Revision - June 29, 1954

PUNAHOU SEPARATION

MAUKA ARTERIAL

SHEET No. 1 OF 8 SHEETS

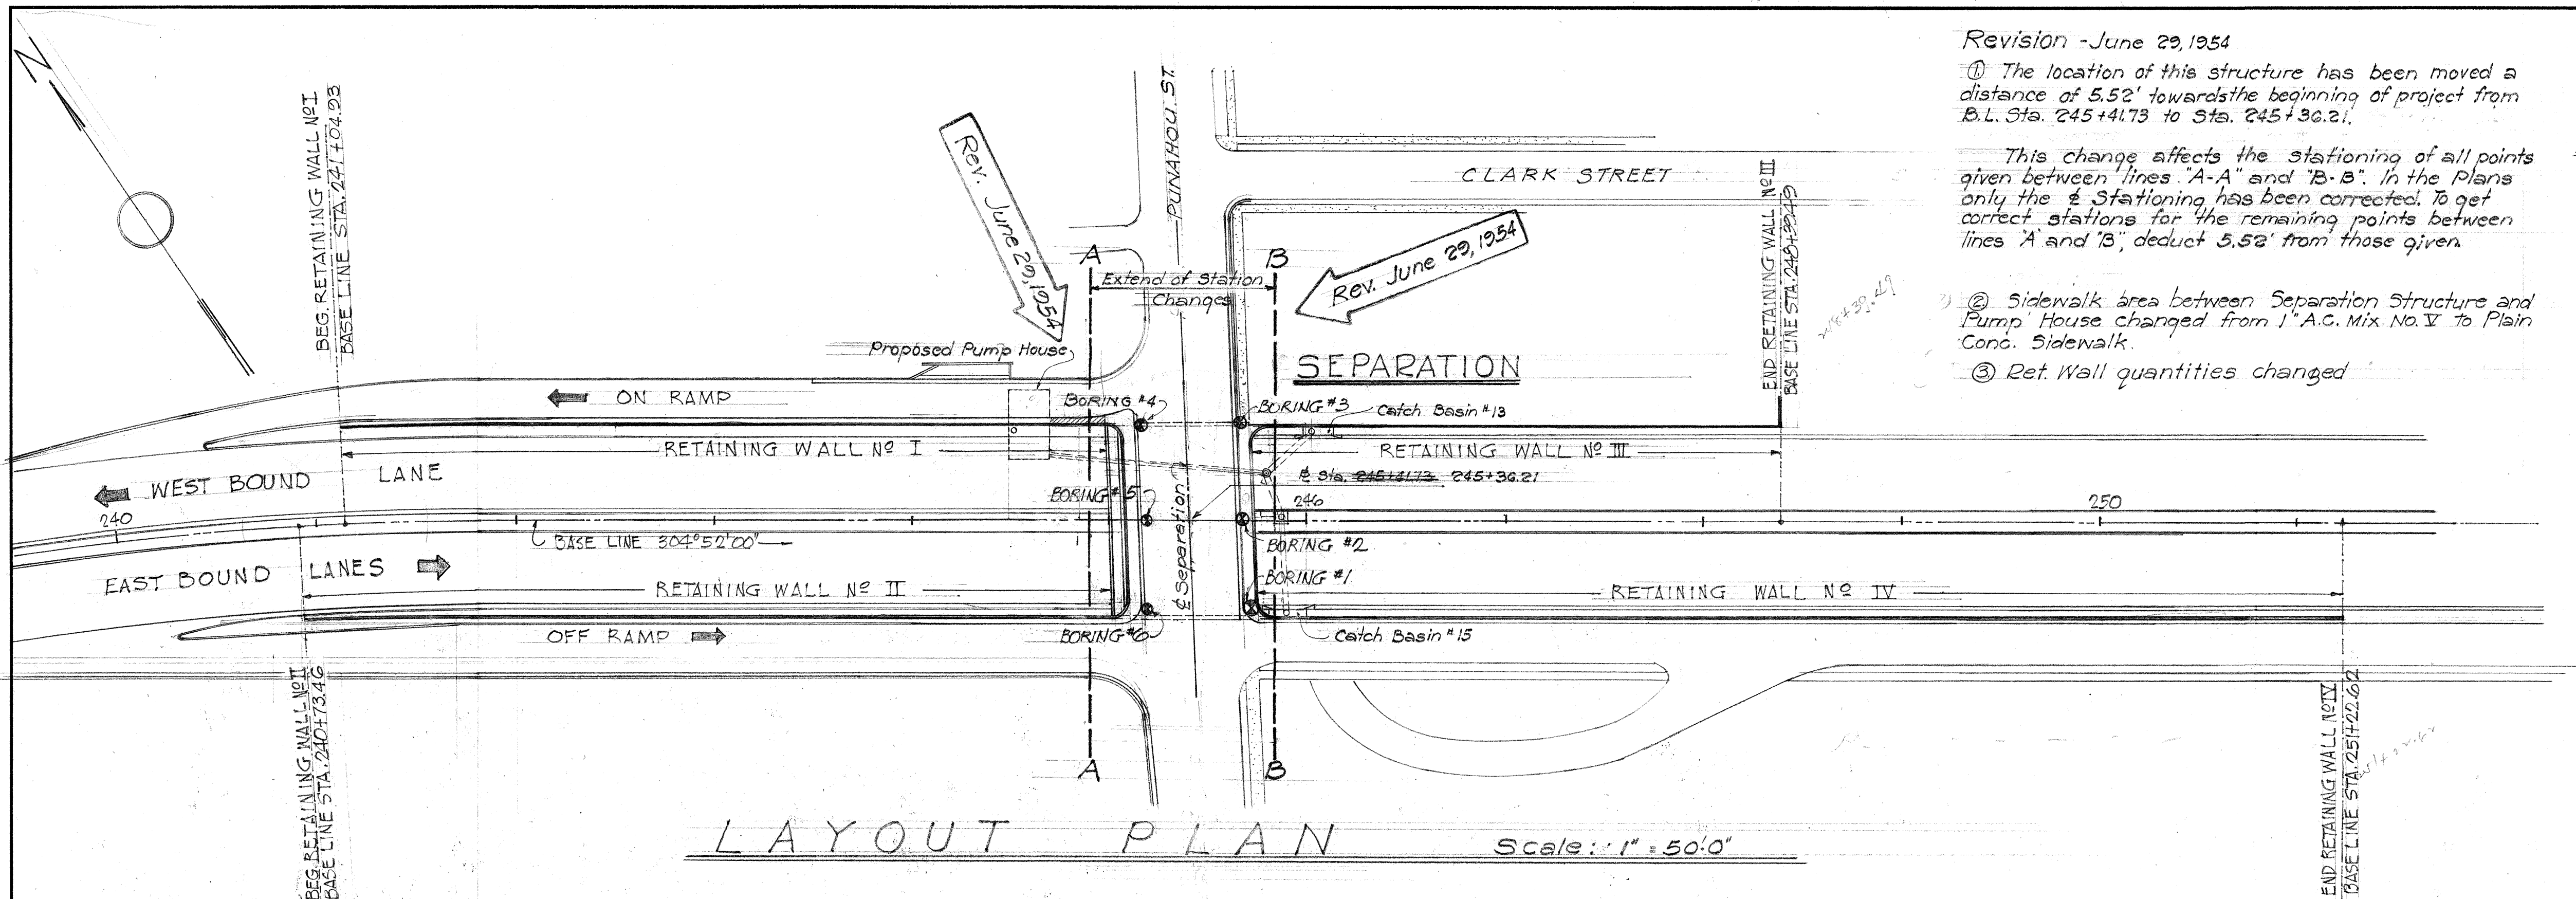
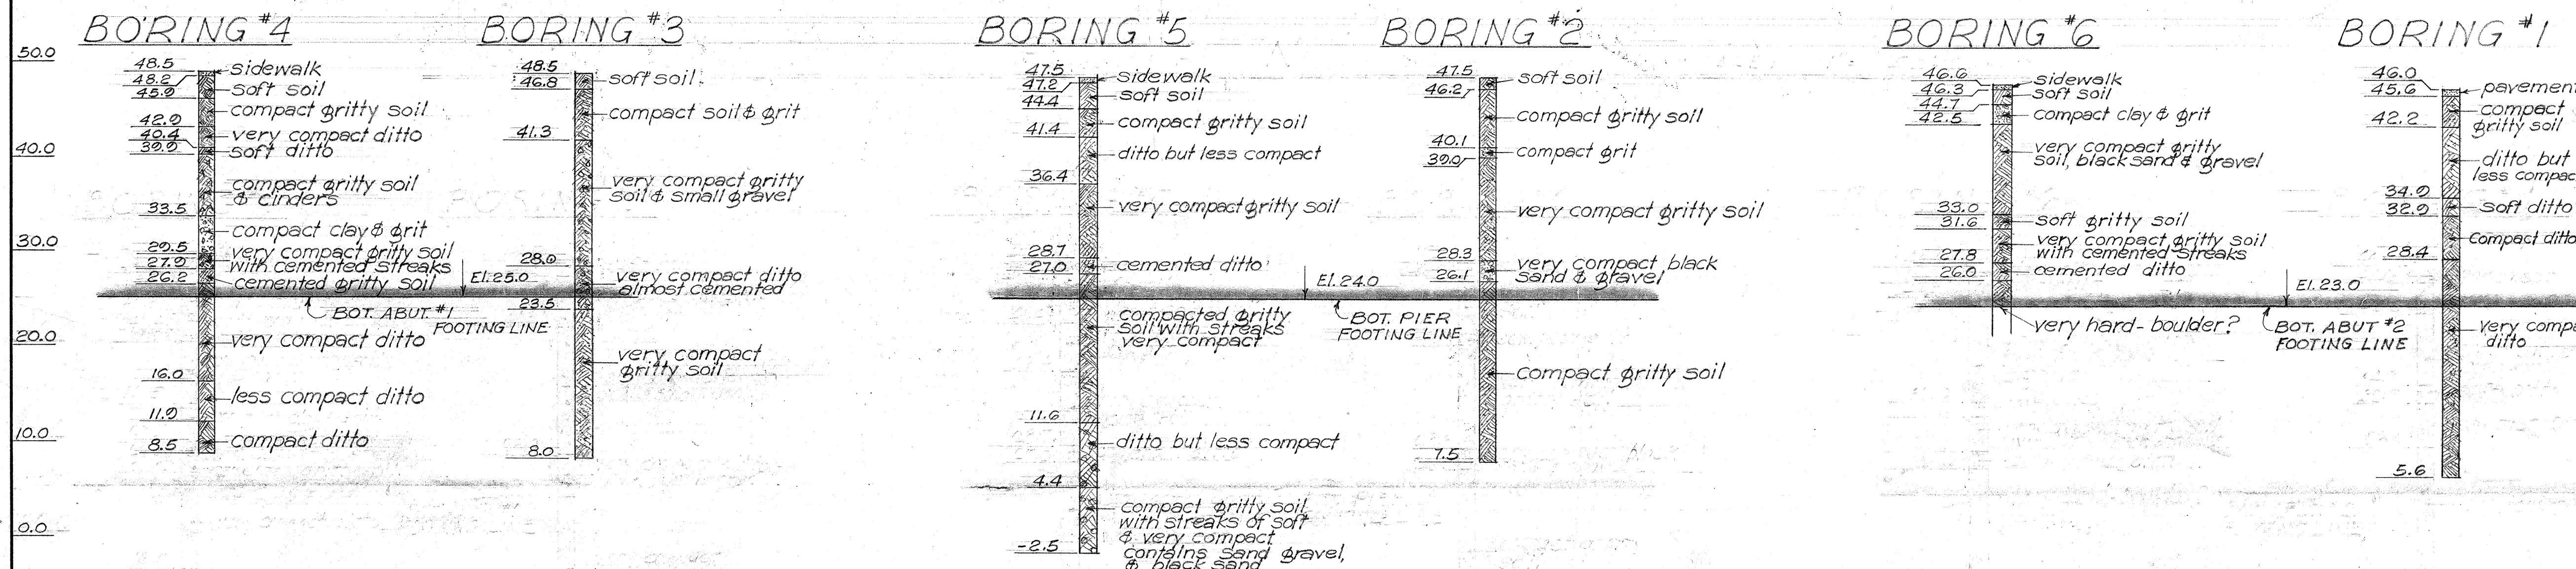
① The location of this structure has been moved a distance of 5.52' towards the beginning of project from B.L. Sta. 245+41.73 to Sta. 245+36.21.

This change affects the stationing of all points given between lines "A-A" and "B-B". In the Plans only the $\frac{1}{2}$ Stationing has been corrected. To get correct stations for the remaining points between lines "A" and "B", deduct 5.52' from those given.

② Sidewalk area between Separation Structure and Pump House changed from 1" A.C. Mix No. V to Plain Conc. Sidewalk.

③ Ret. Wall quantities changed

5627.68

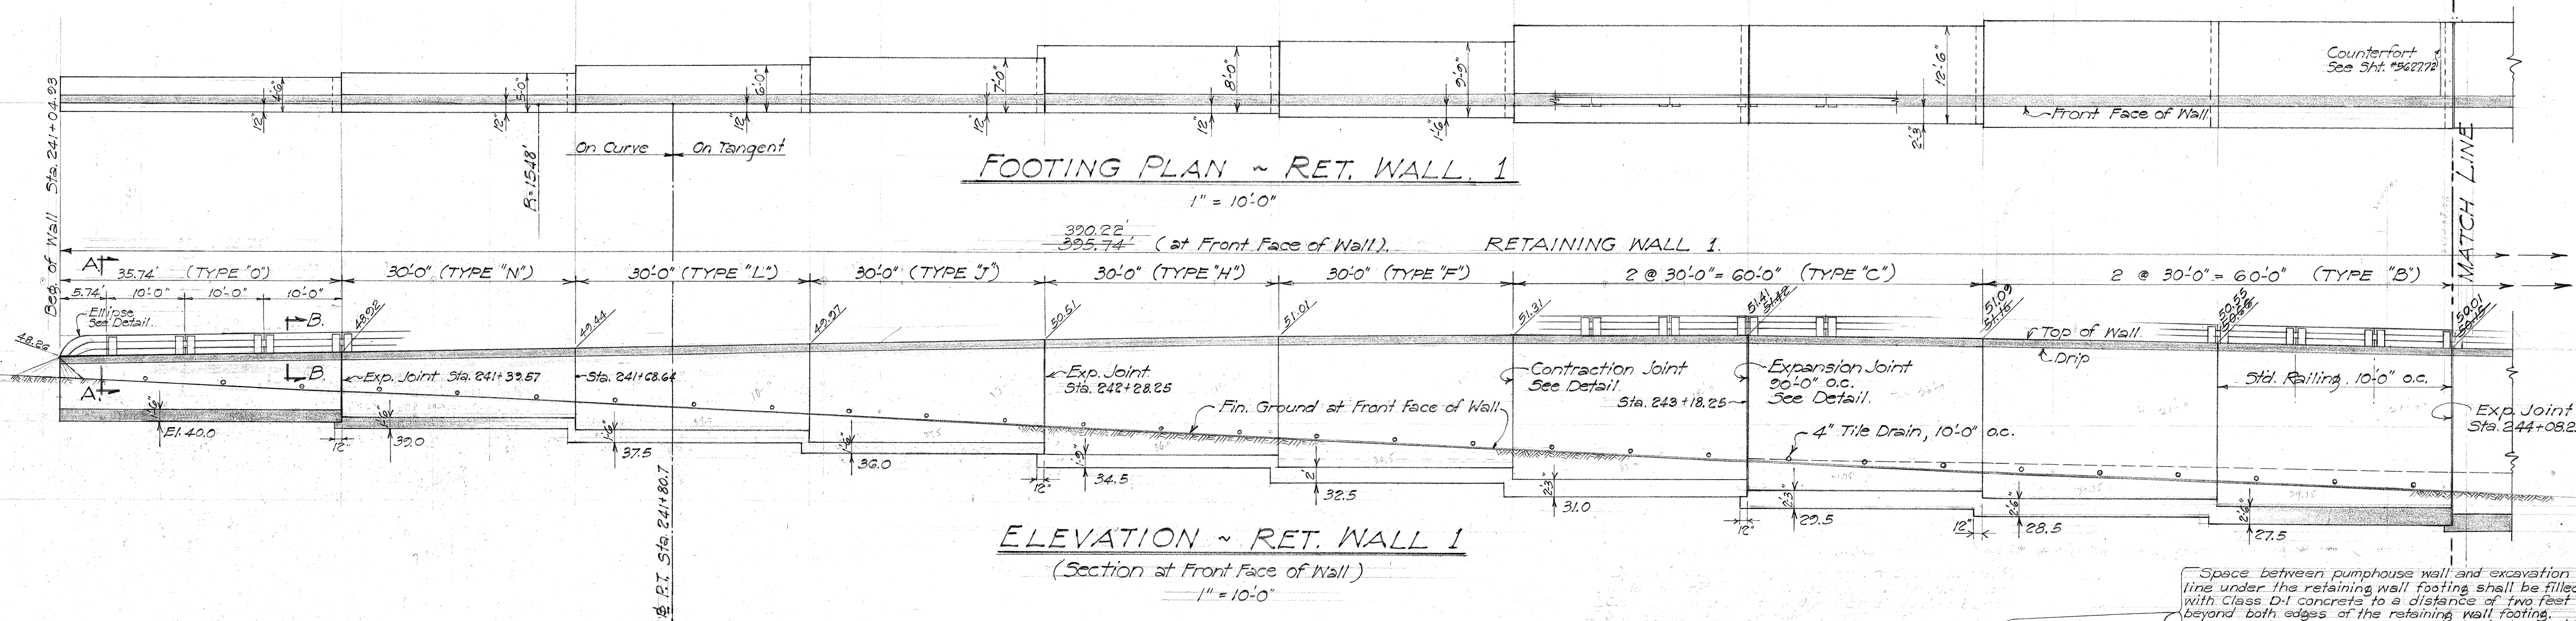
Revision: June 29, 1954
Sidewalk at Ref. Wall II changed from Top Soil
to A.C. Mix No. V. Elevations at top of Ref. Wall
adjacent to Separation Structure changed.

Revision: June 29, 1954. Grades revised as shown. Retaining wall adjacent to Separation structure shortened 5.52' and railing spacings readjusted accordingly.

3627.69

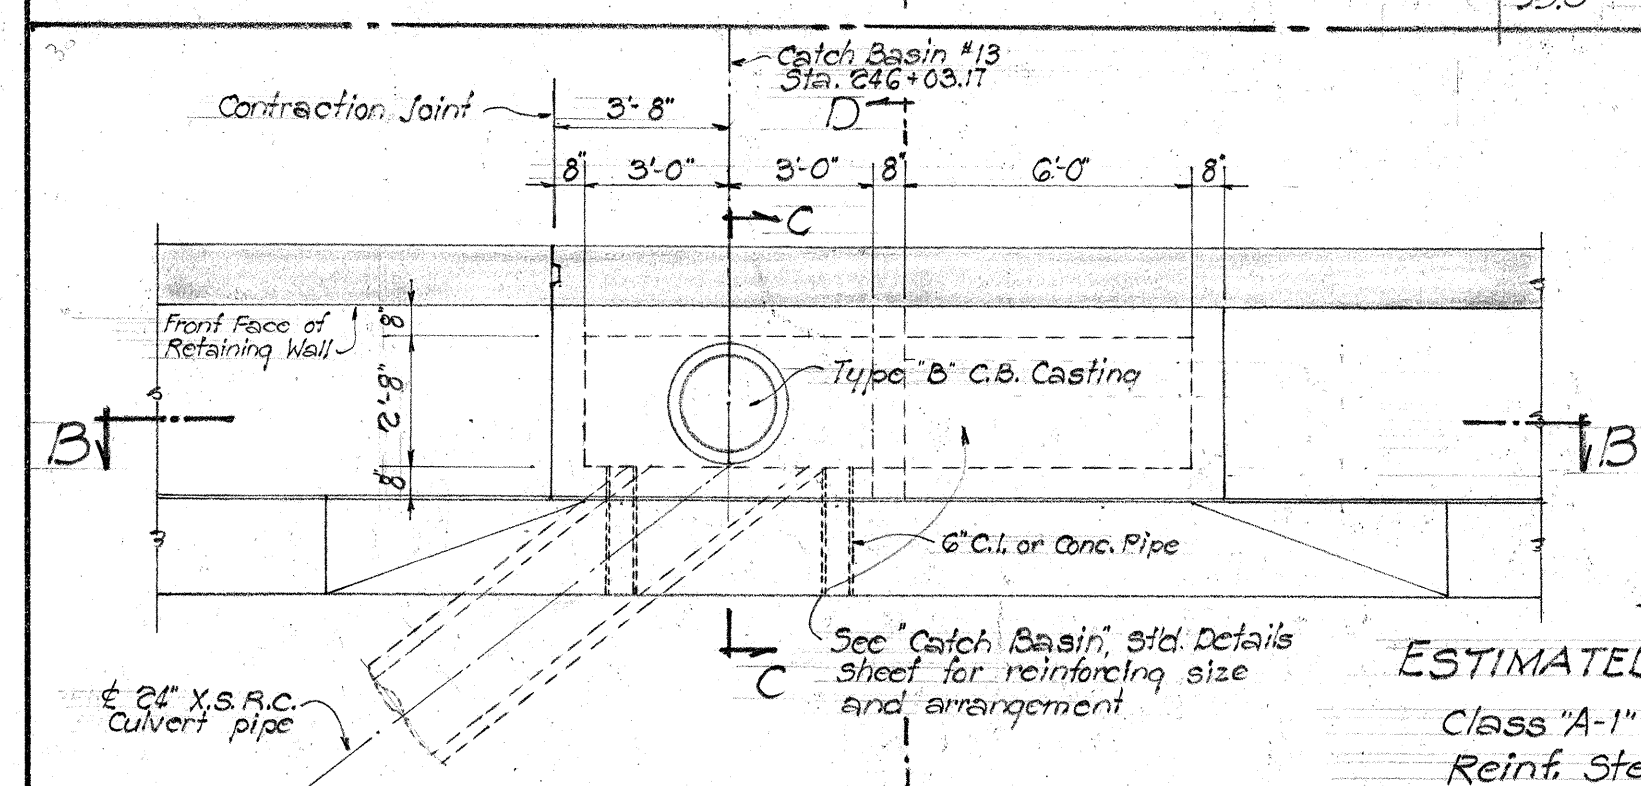
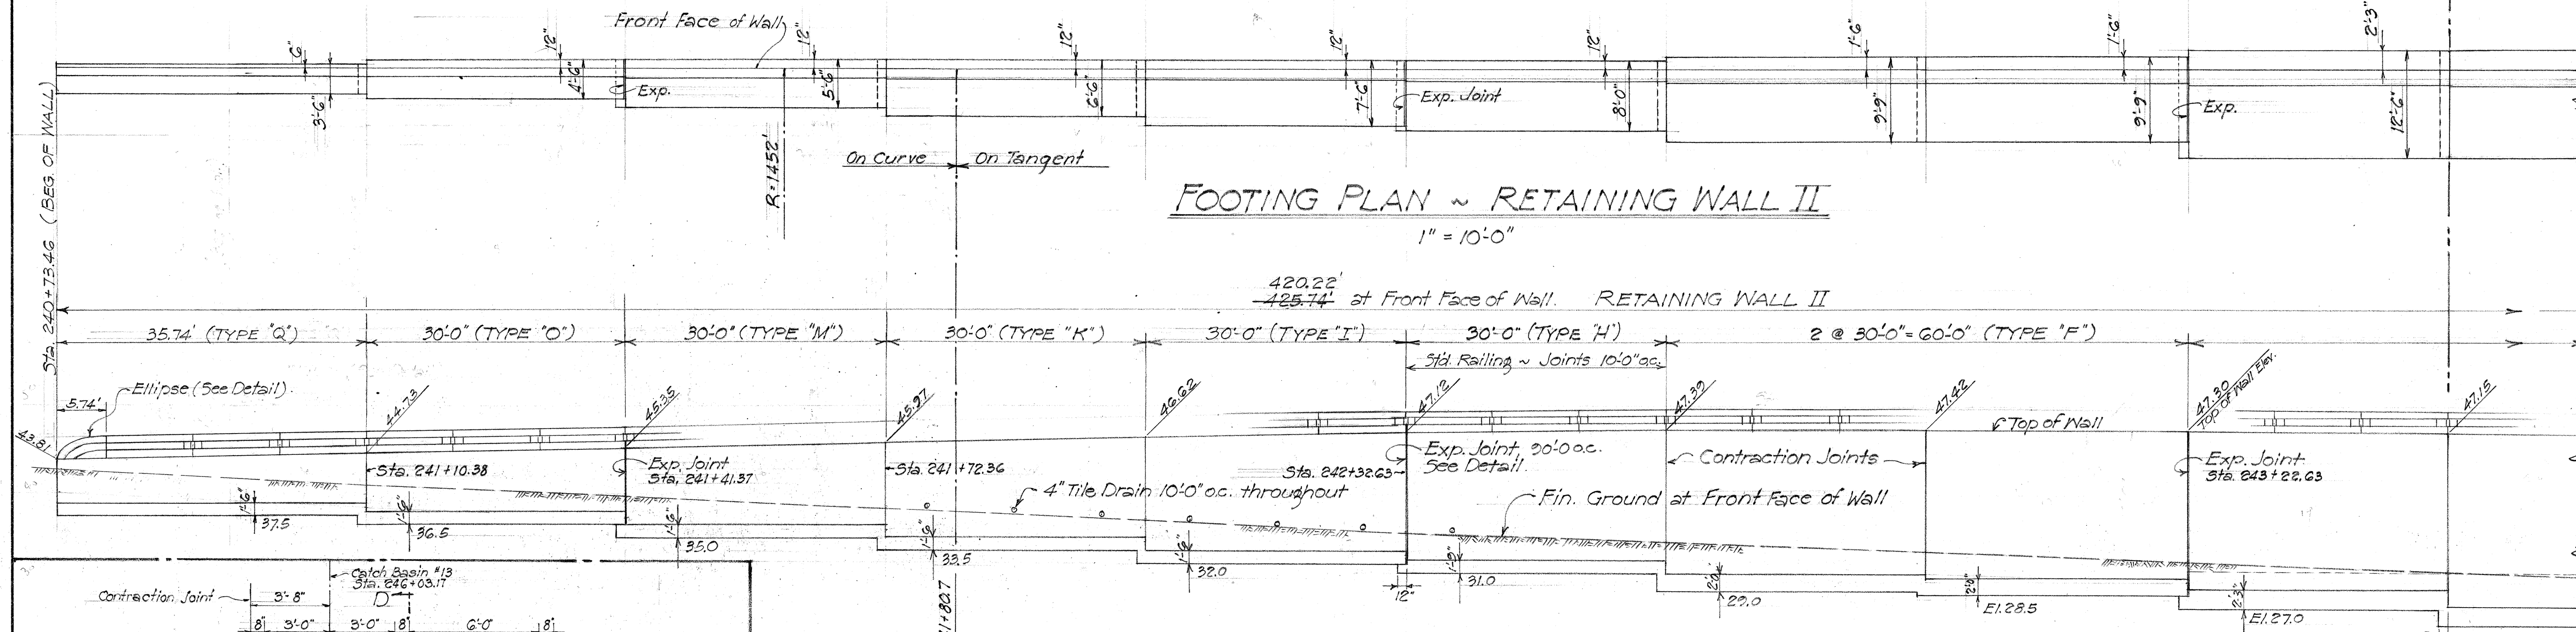
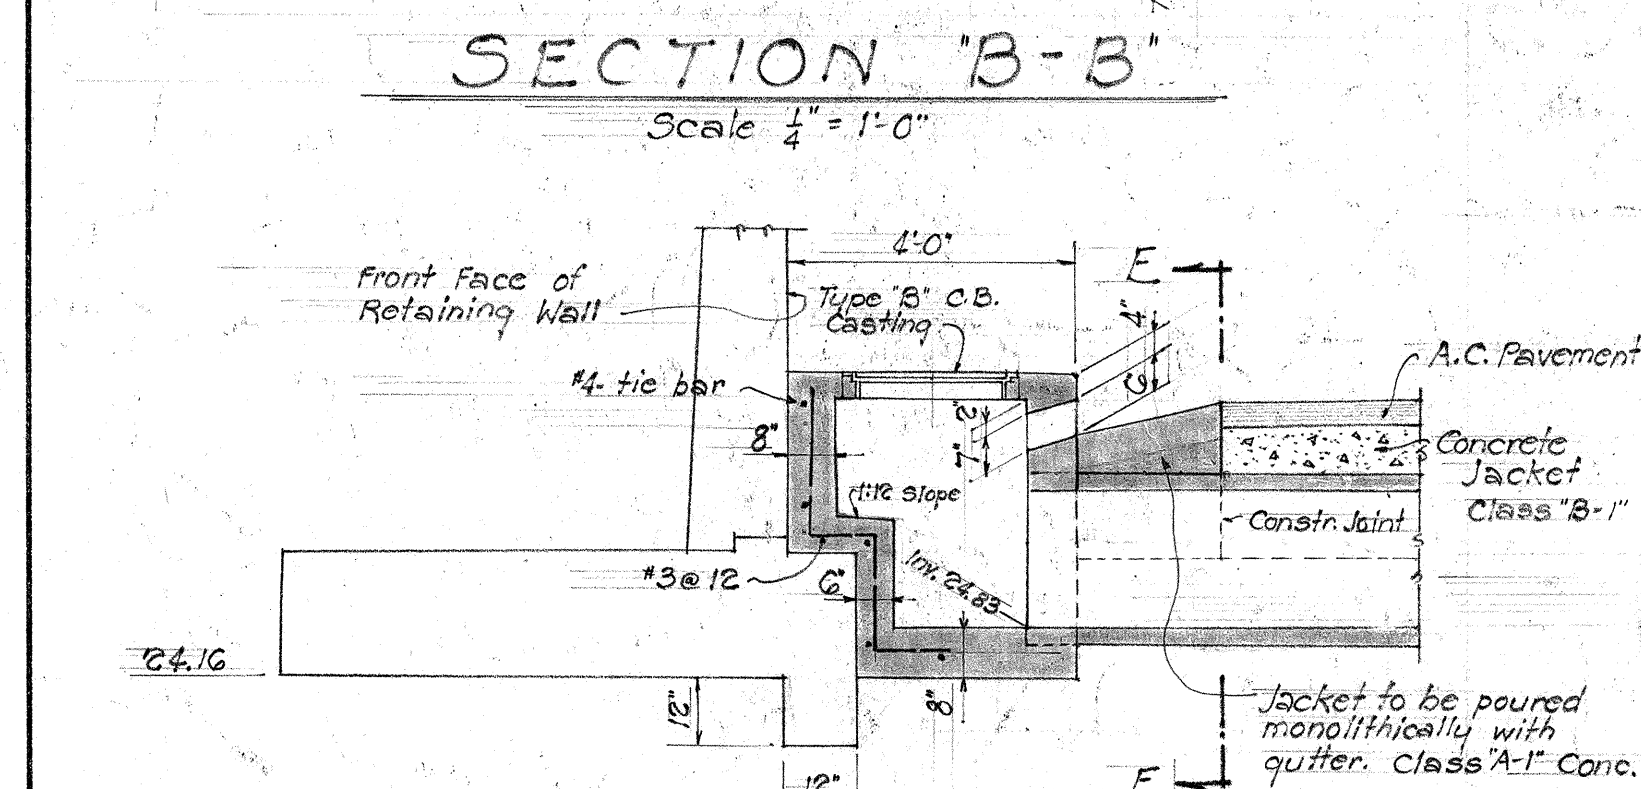
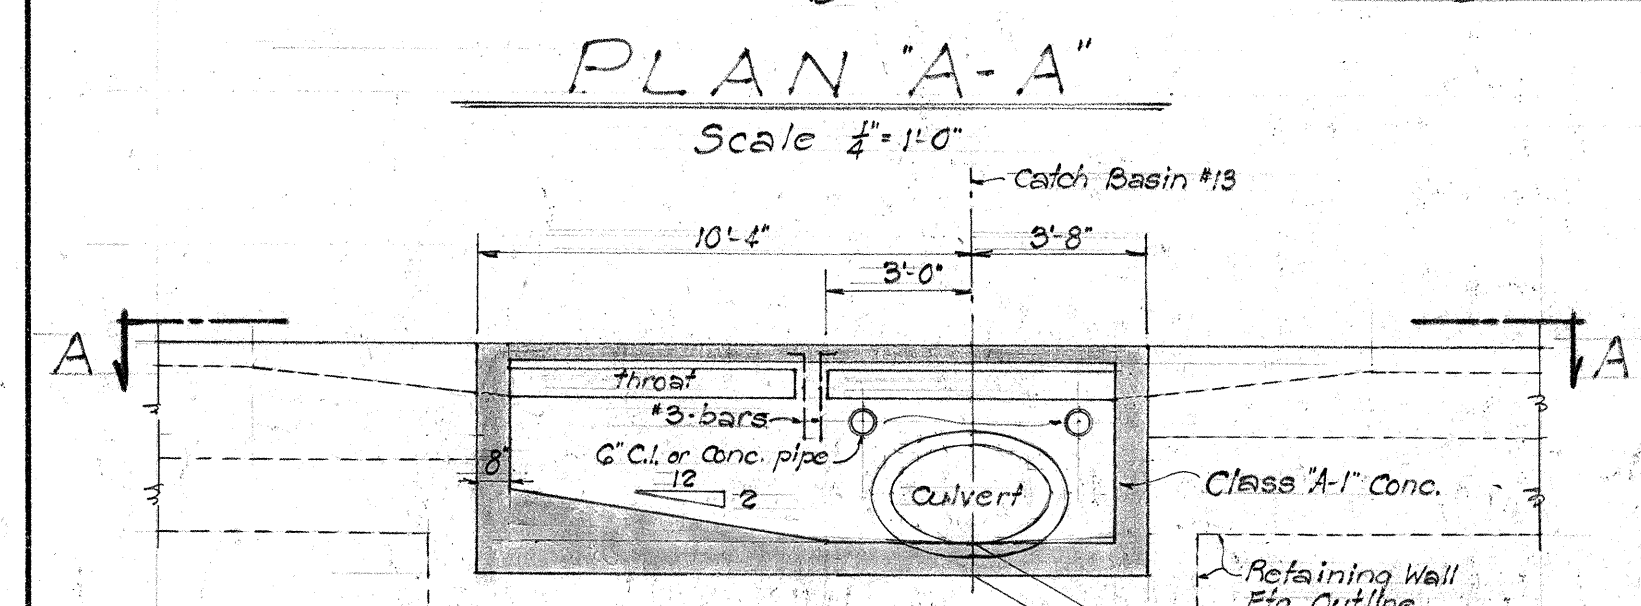
Revision: June 29, 1954. Retaining wall panel adjacent to separation structure shortened 5.52'. Grades and railing spacings readjusted accordingly.
